**COLLEGE OF DUPAGE
REGULAR BOARD MEETING**

McAninch Arts Center (MAC) 153 Classroom Renovation Project General Contractor

This addendum is being issued to update the specifications and provide additional information.

EXHIBIT A – QUESTIONS AND ANSWERS

EXHIBIT D – SPECIFICATION DRAWINGS

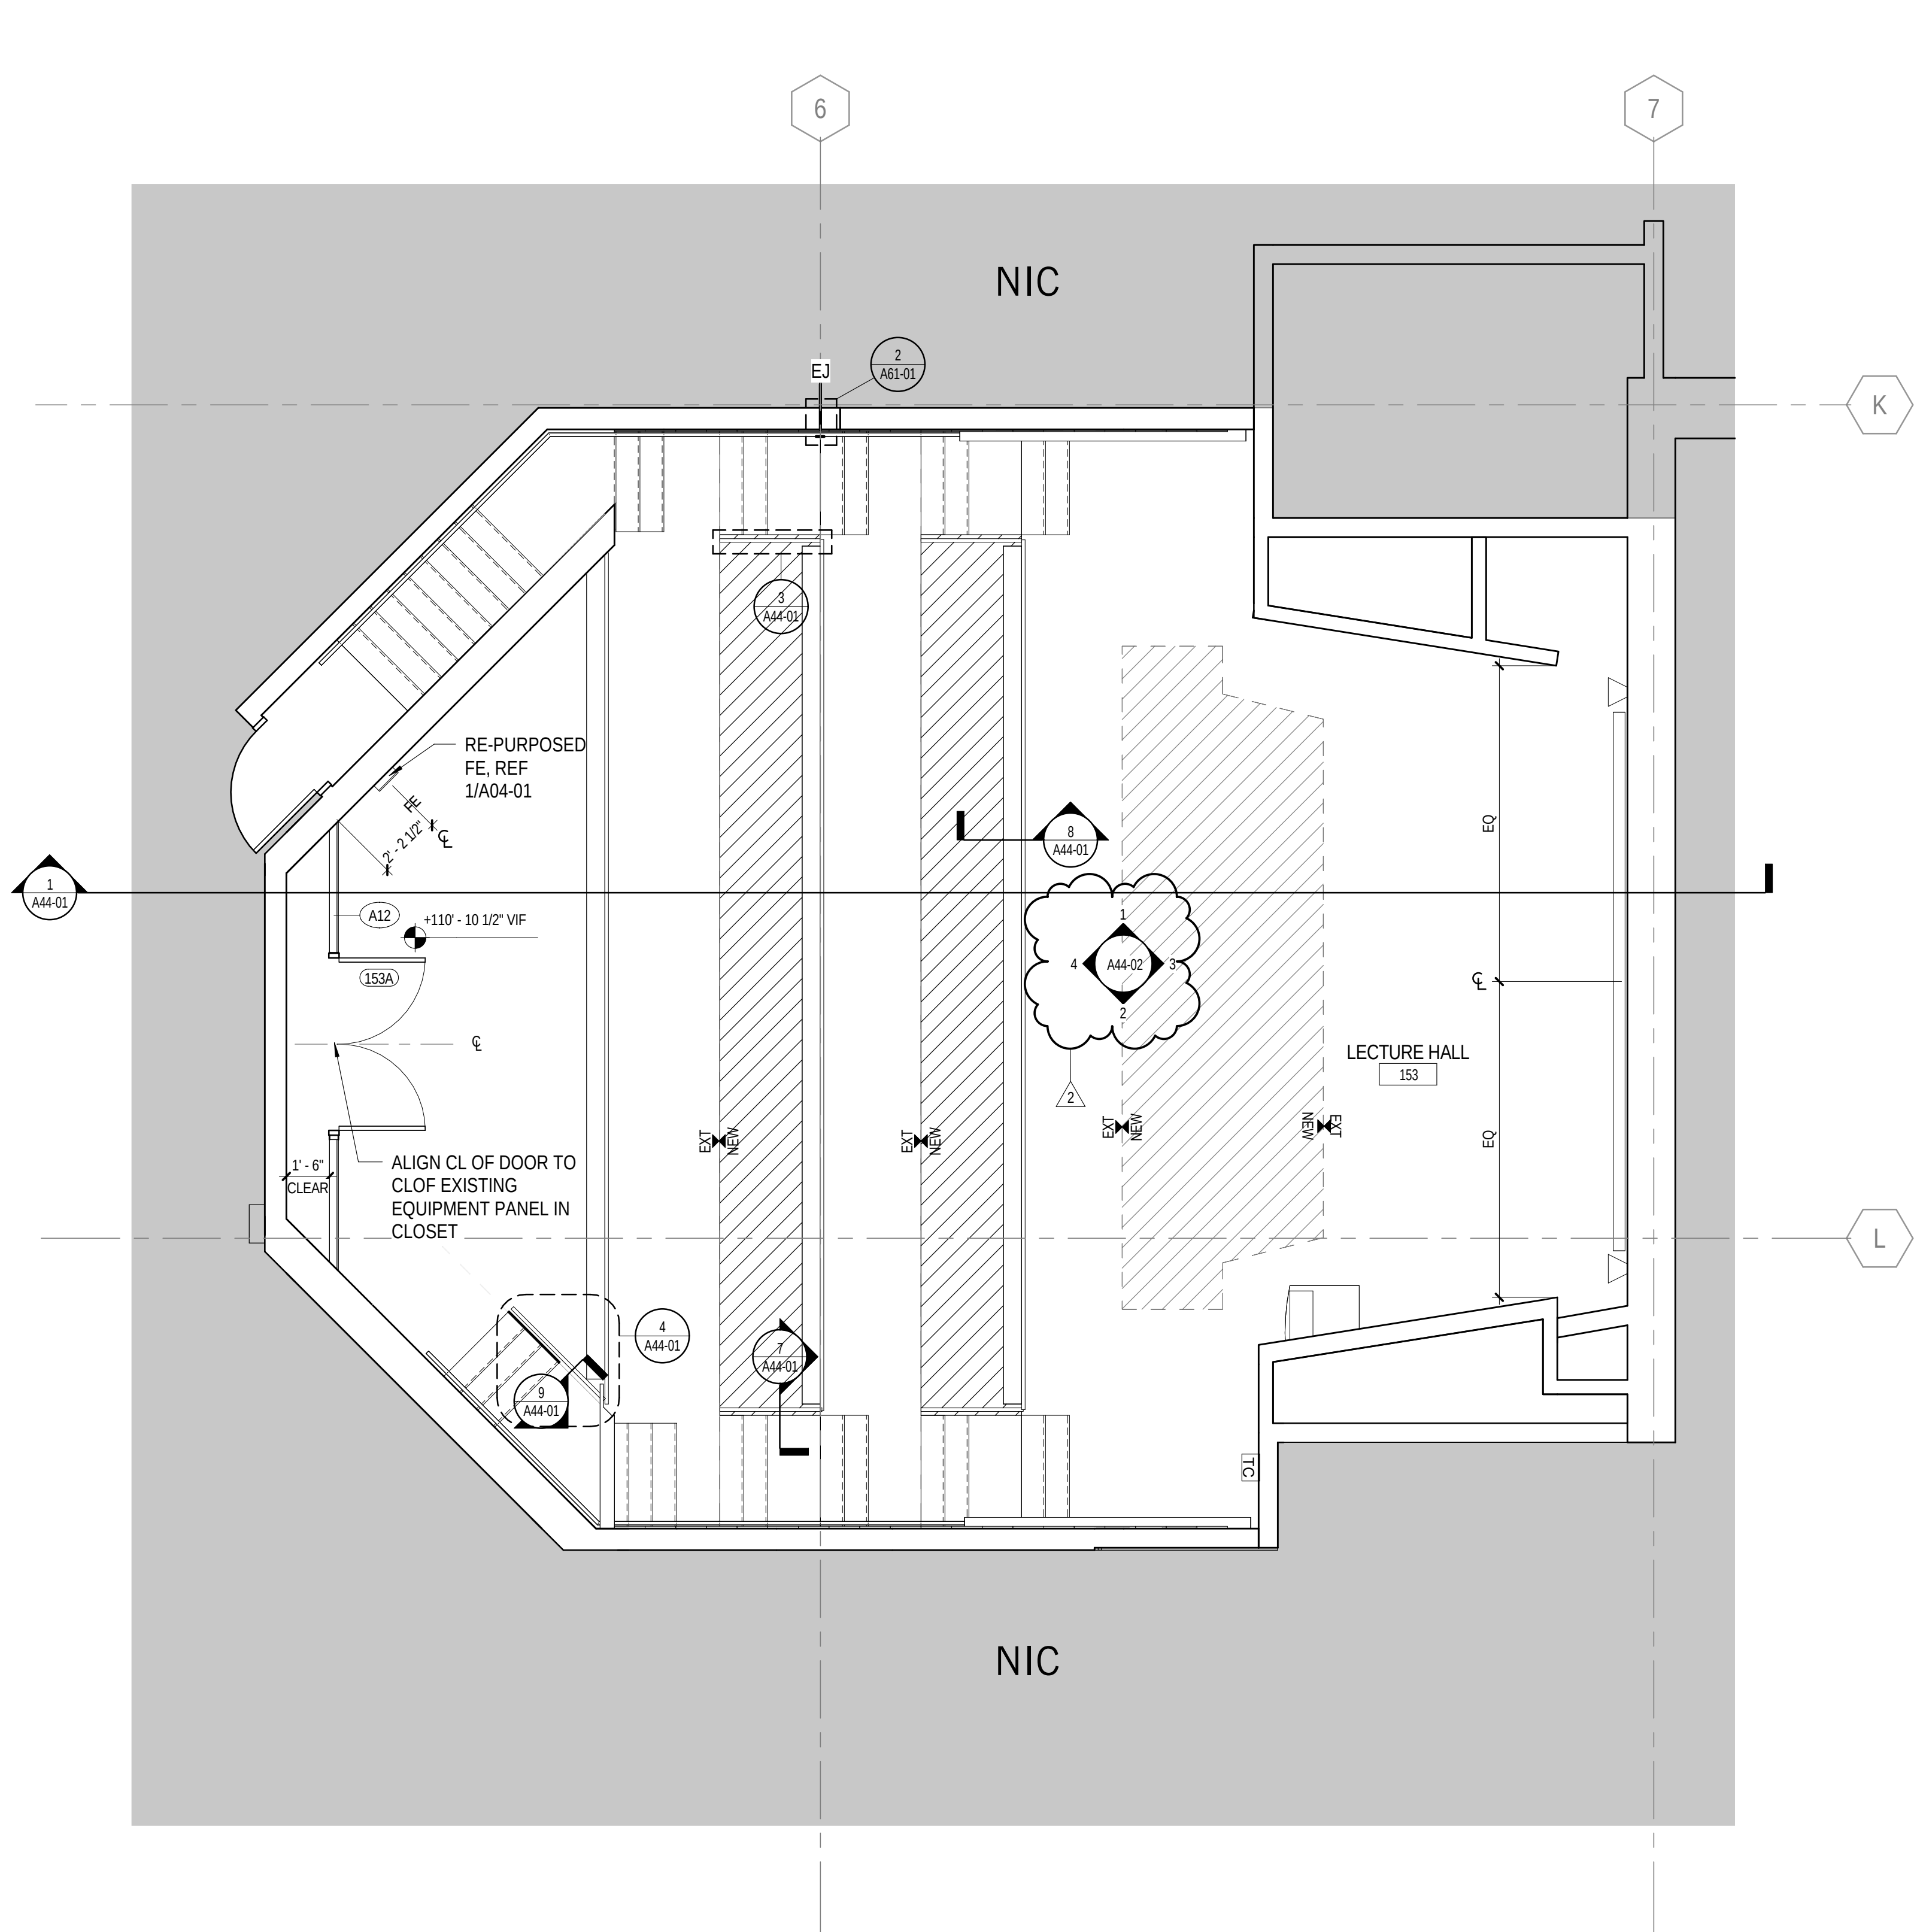
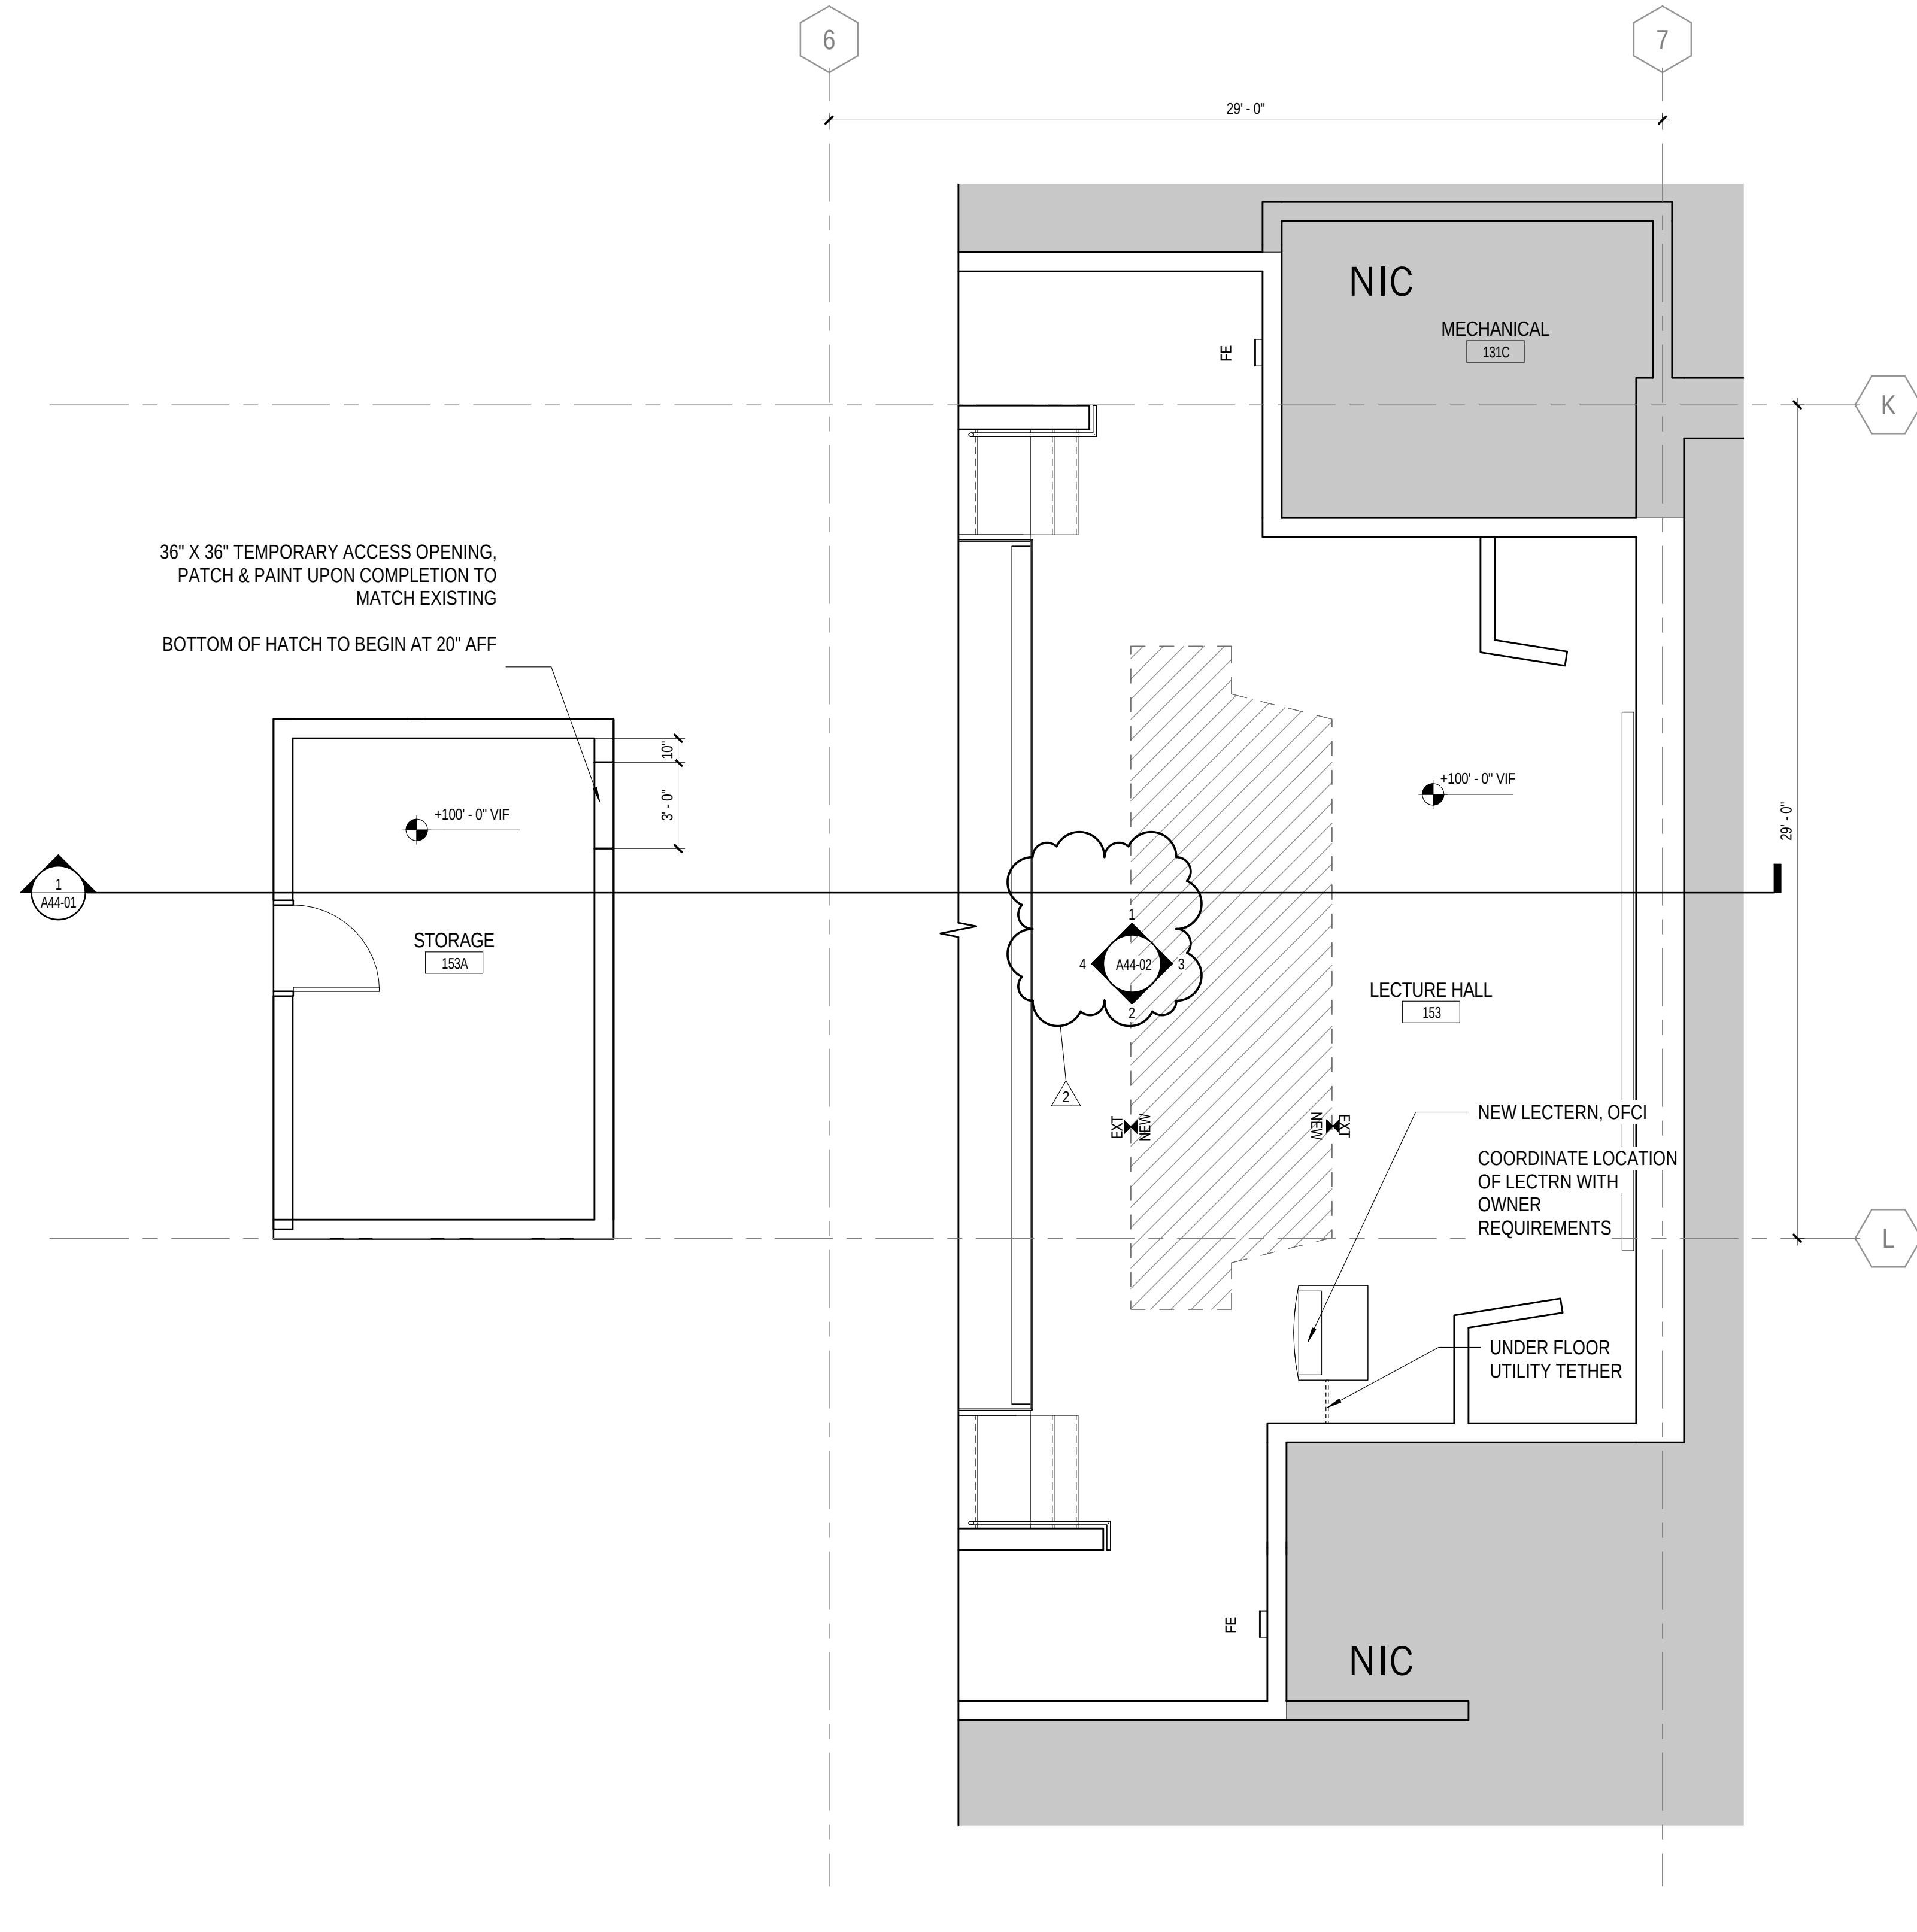
A1 – The Pres Elevation nomenclature is in error, Revised drawing A11 issued with this addendum removes that erroneous language.
